Office Action Summary

10/773,614

BRENNAN ET AL.

**FIG. 9E**

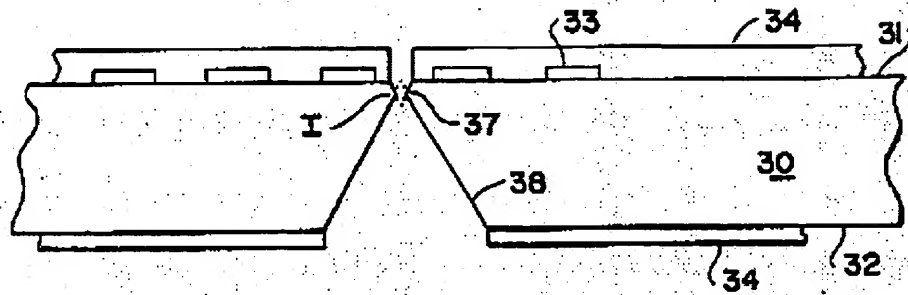
Applicants argue that “the prior art fails to teach or suggest joining the first and second adjacent sides of the IC, die the chamfer having upper surface which is angled relative to the first and second adjacent sides...”

In response to applicants argument, it is respectfully submitted that Drake et al. '821 disclose all the claimed limitations including the limitation *joining the first and second adjacent sides of the IC, die the chamfer having upper surface which is angled relative to the first and second adjacent sides.*

As depicted on Fig. 9E above, the chamfer (37) (i.e., upper surface) the bottom groove (38) (i.e., the bottom surface) are joined (i.e., the top and bottom sides of the IC die connected through the via and detached). In addition the chamfer 37 is angled relative to the front and the back side of the IC chip.

Therefore, the rejection of claims 1-24 under 35 U.S.C. 102 is deemed proper.
